TOWN OF FAIRFAX
STAFF REPORT
Department of Planning and Building Services

TO:	Fairfax Planning Commission
DATE:	October 16, 2014
FROM:	Jim Moore, Director of Planning and Building Services Linda Neal, Senior Planner
LOCATION:	145 Ridgeway Avenue; Assessor's Parcel No. 001-203-04
ZONING:	Residential Single-family RS 6 Zone District
PROJECT:	Deck Addition
ACTION:	Use Permit; Application # 14-38
APPLICANT:	Rich Rushton, Rushton Chartock Architects
OWNER:	Brooke and Matt Golden
CEQA STATUS:	CEQA categorically exempt, §15301(a)

2014STAFFREP/145 ridgeway.pcstaffrep.10_16_14/ln

AGENDA ITEM # 2

1 SITE PLAN

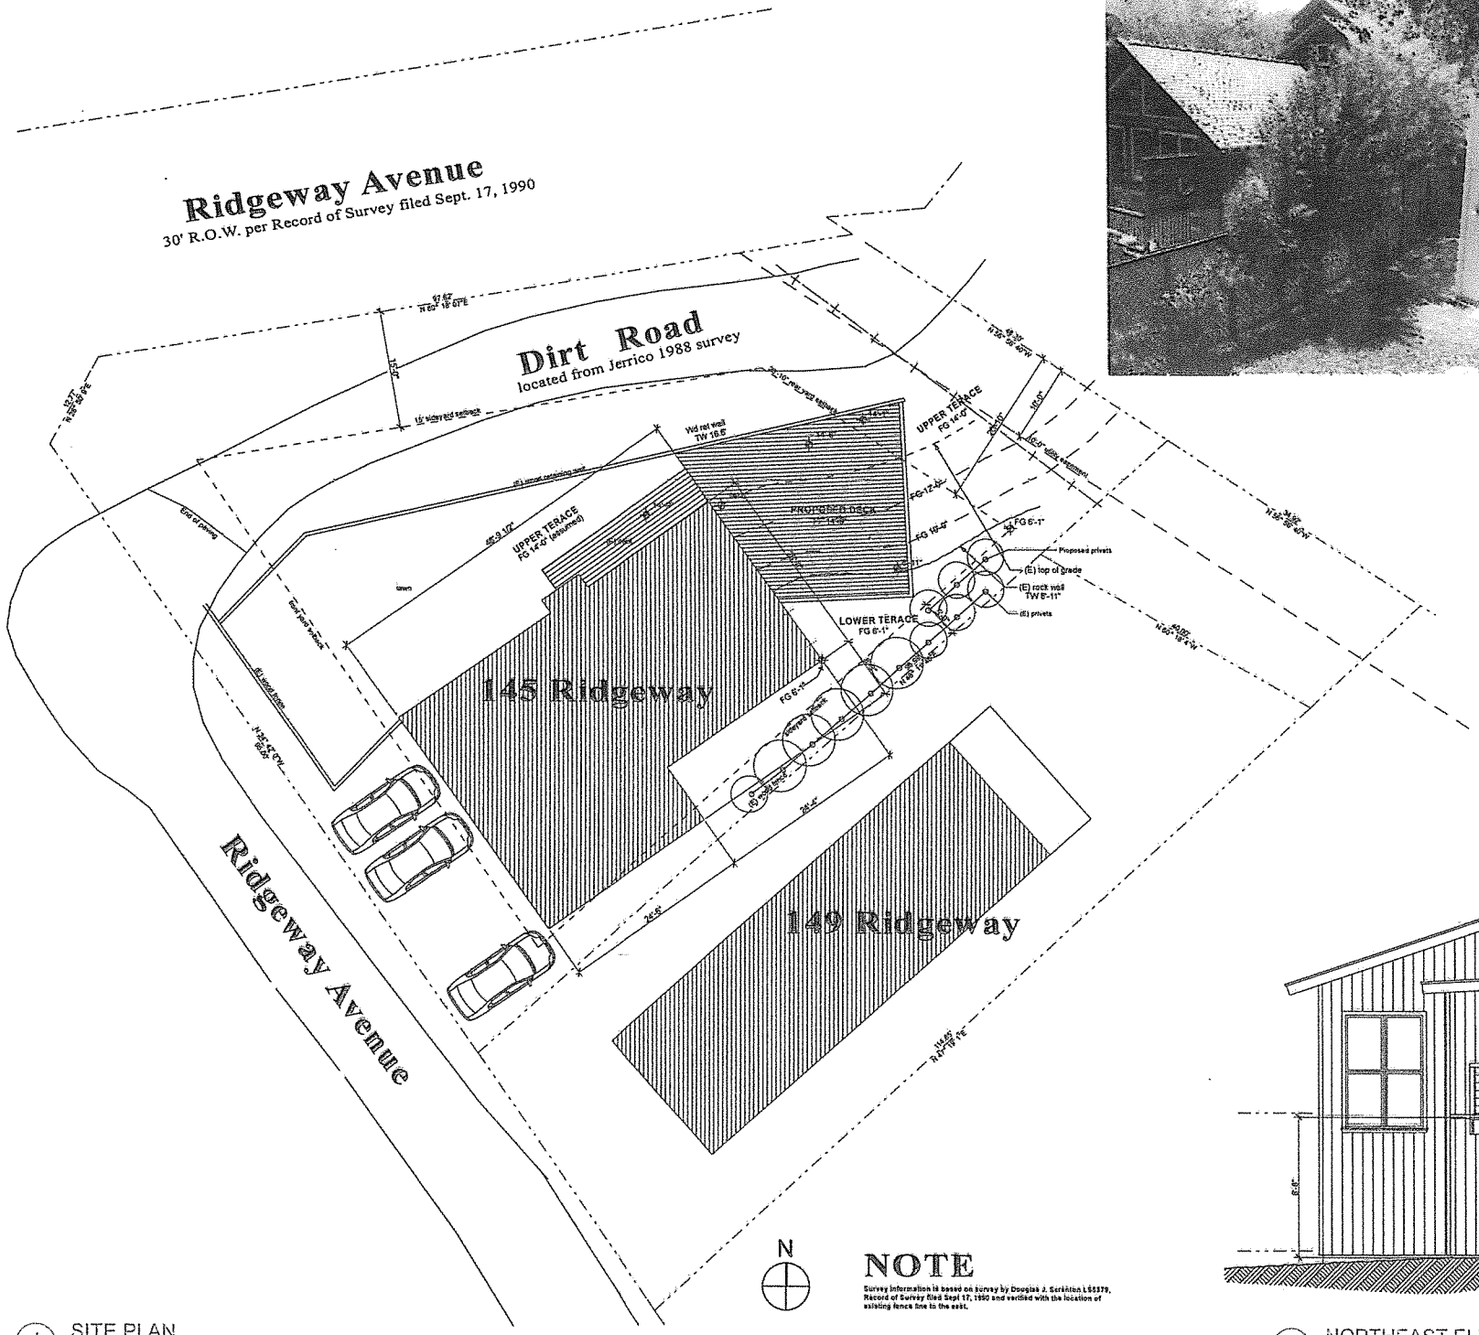
However, the neighboring property at 149 Ridgeway is very steep and small with the only somewhat level outdoor area located immediately adjacent to the northern fence between the properties and the small second floor rear deck. It is staff's opinion that the proposed deck at 145 Ridgeway Avenue will significantly impact the property at 149 Ridgeway as it is currently proposed and we are unable to make the following required

Staff has discussed our inability to make the required findings with the project architect. We are unable to find that the deck is necessary to allow the owners a significant use of the property because they still have a use of the rear yard which is terraced without the construction of the proposed deck.

The architect has provided a proposed landscaping plan including the planting of 3 additional fast growing privets along the side property line between the two residences. He also indicated that the owners are willing to construct a privacy screen along the south side of the deck to minimize its impact on the neighbors.

3. The building permit plans shall also include a privacy screen along the southern side of the deck and perhaps along a portion of the eastern side of the deck and shall be approved by the owner of the property at 149 Ridgeway Avenue prior to issuance of the building permit. If agreement cannot be reached on the appropriate extent and/or location of the privacy screen by the two property owners, they shall meet with staff to try a reach a resolution; and, if a resolution cannot be reached with staff mediating the matter shall be scheduled for a hearing before the Commission for the Commission to decide the screen extent

1 DECK PLAN
SCALE: 1/4" = 1'-0"

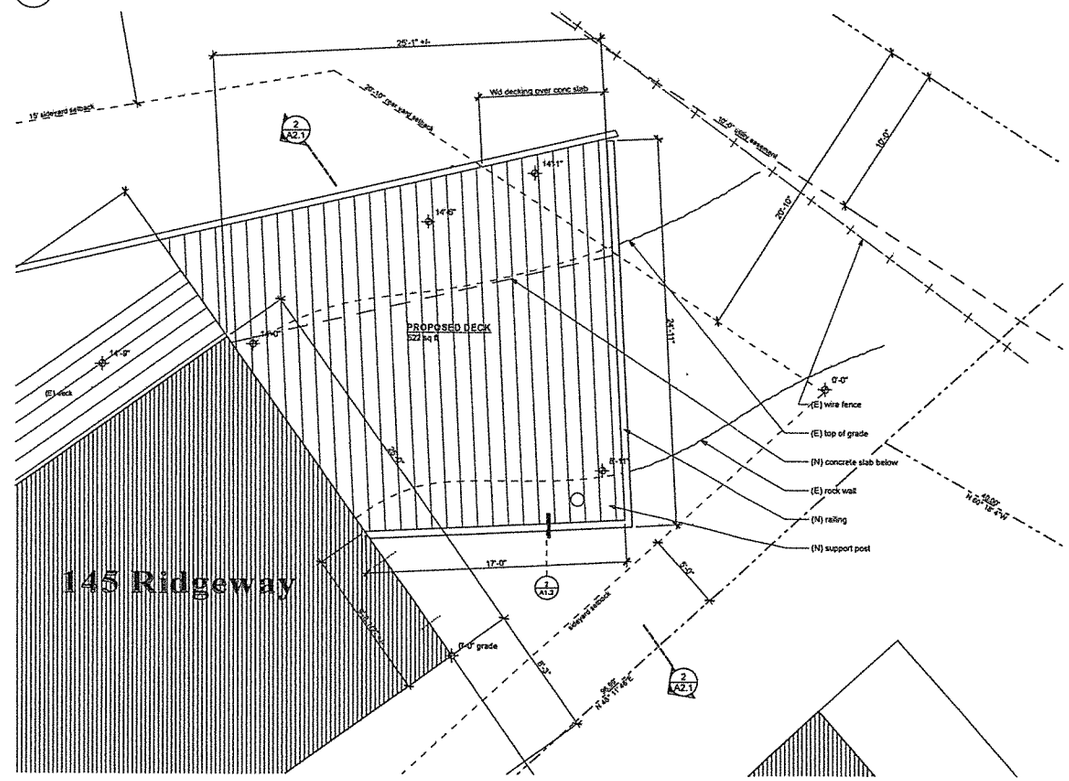
The project encompasses construction of a 522 square foot deck off of the second living level that will extend up to 12.5 feet above grade at its tallest point.
